City of Richmond

Report to Development Permit Panel

File: DP 20-896600

Re: Application by Headwater Living Inc. for a Development Permit
at 5500 No. 3 Road

2 BUILDING WEST ELEVATION
A306. SCALE: 1/16" = 1' - 0"

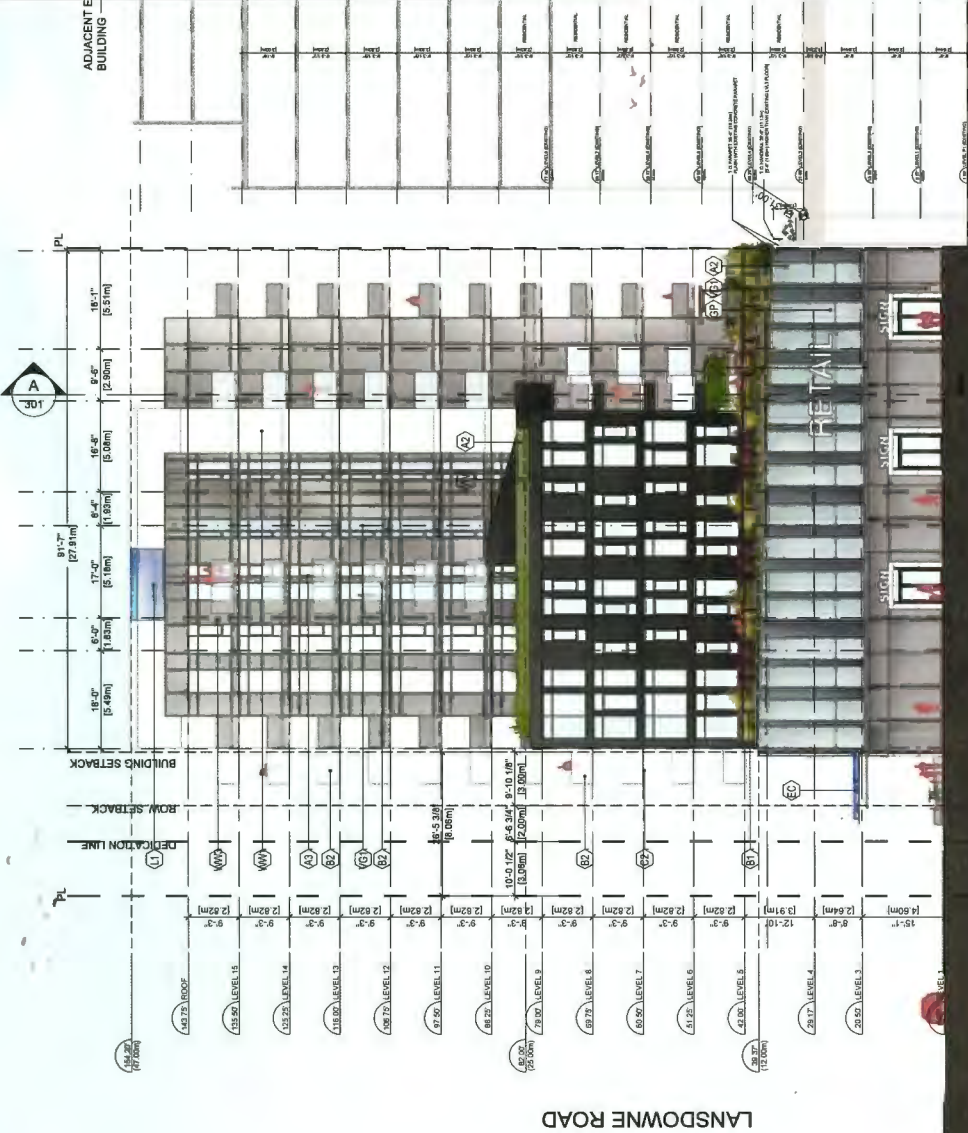
- The building's west façade needs more articulation to better address No. 3 Road, which is a major road in Richmond – ***Design improved with additional elements to create a more granular streetscape; separated entry door portals and sign locations for CRU units add articulation and pedestrian-orientation to this façade.***

1 Section through 9th level amenity area
Scale: 1:100

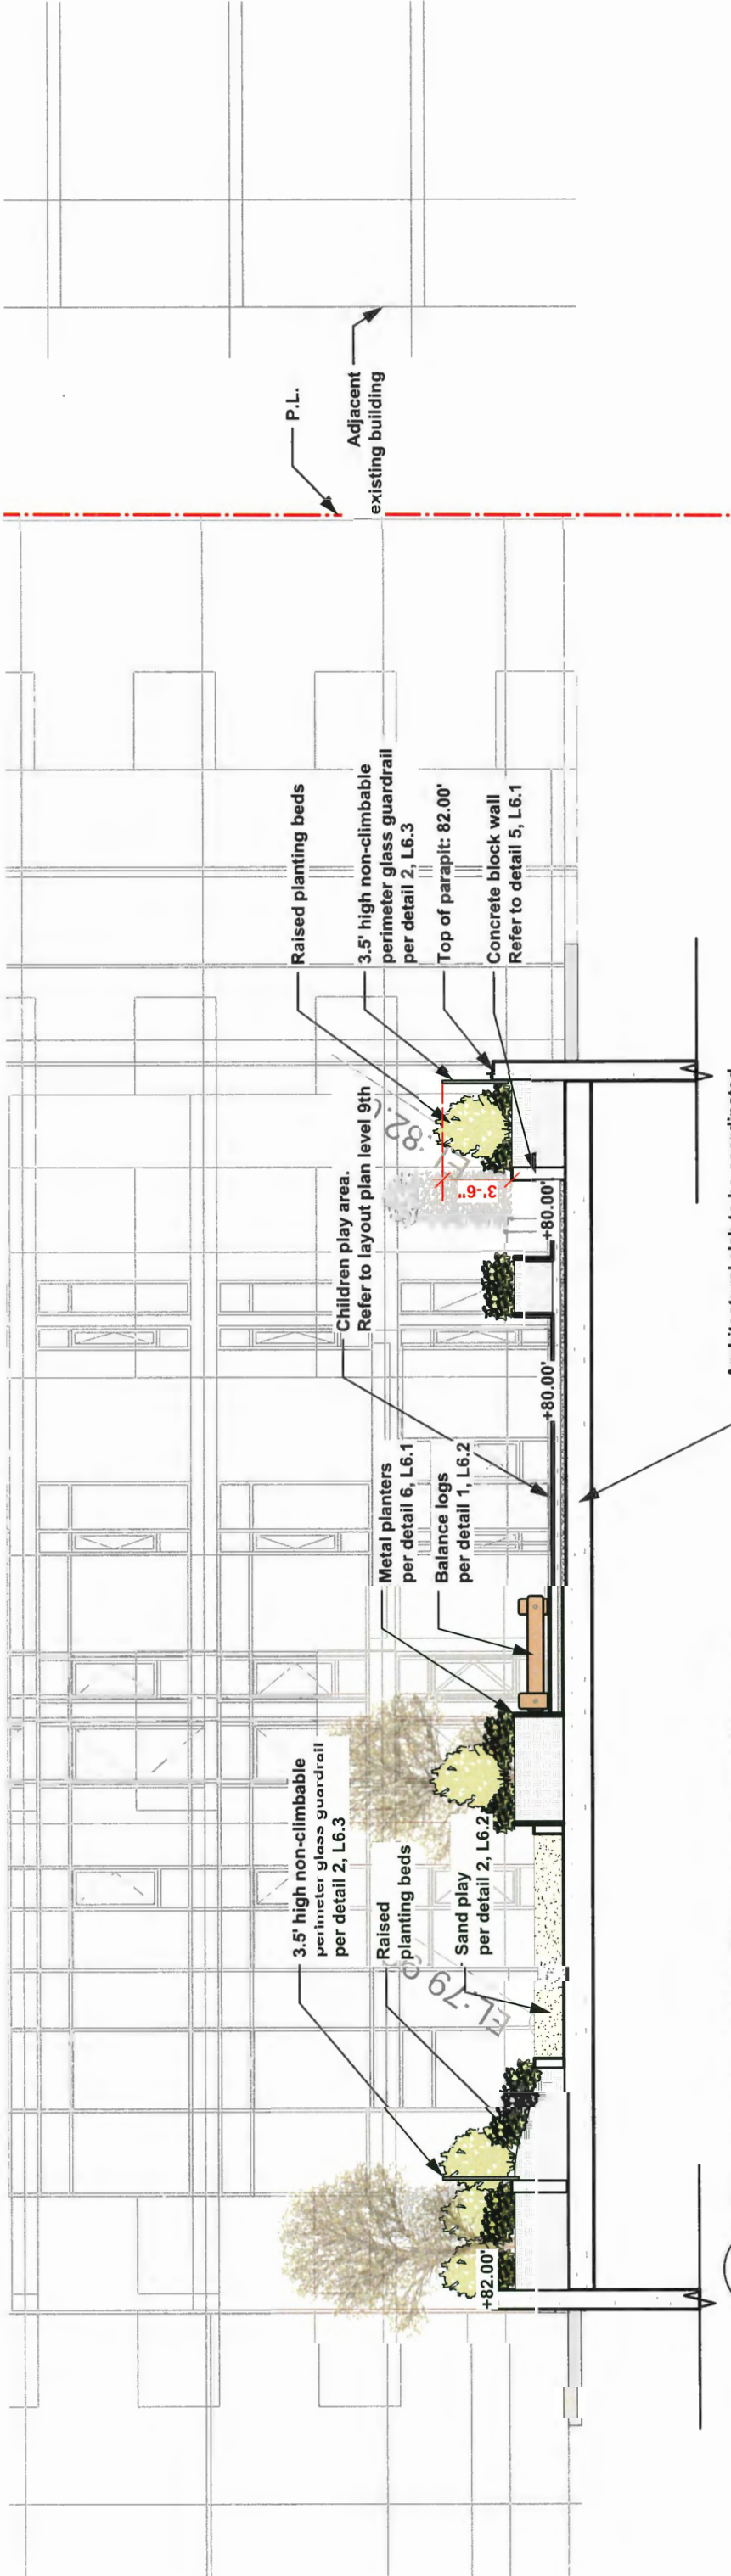
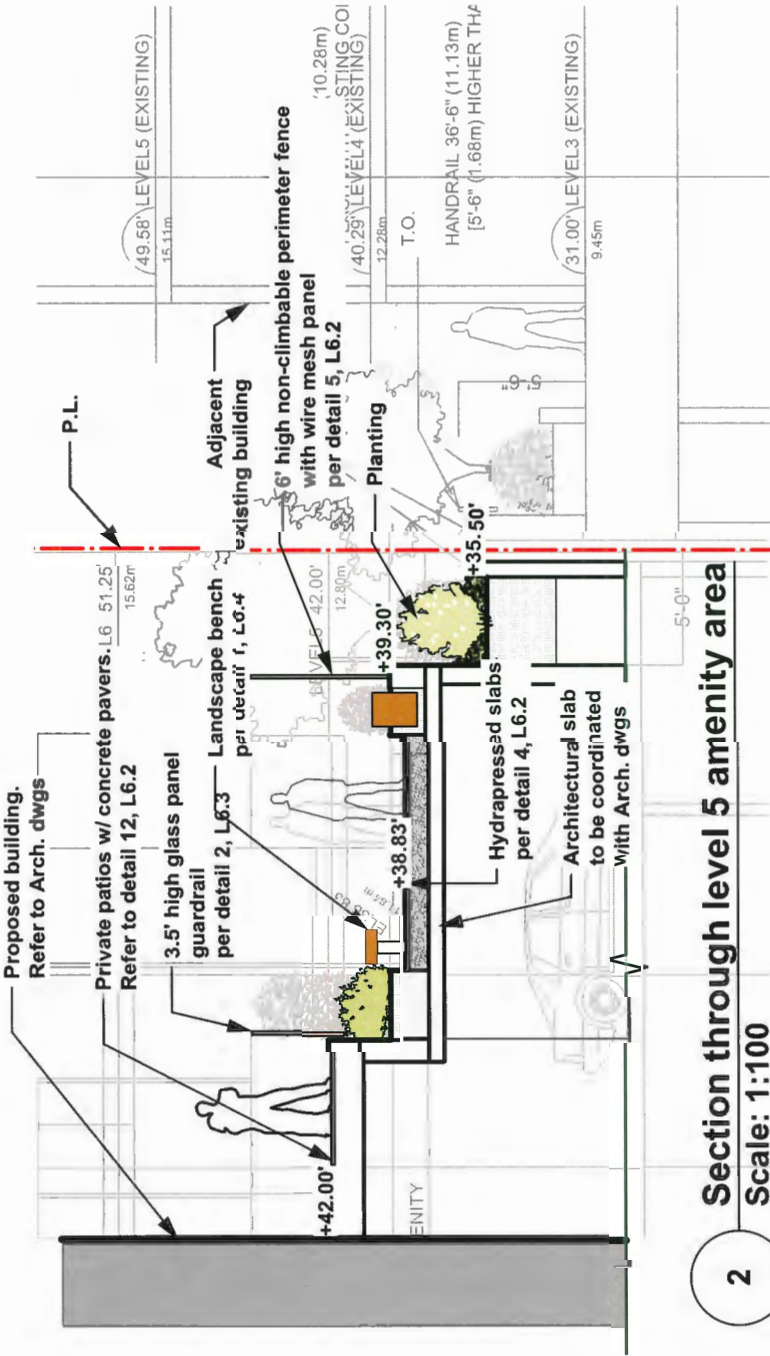
- Appreciate the programming of the common outdoor amenity space on Level 9 which provide for a diversity and flexibility of uses for residents, including children; consider providing additional shading through either enhancing the proposed trellis to provide more shade or installing outdoor umbrellas and canopies – ***Trellis design improved as noted above.***
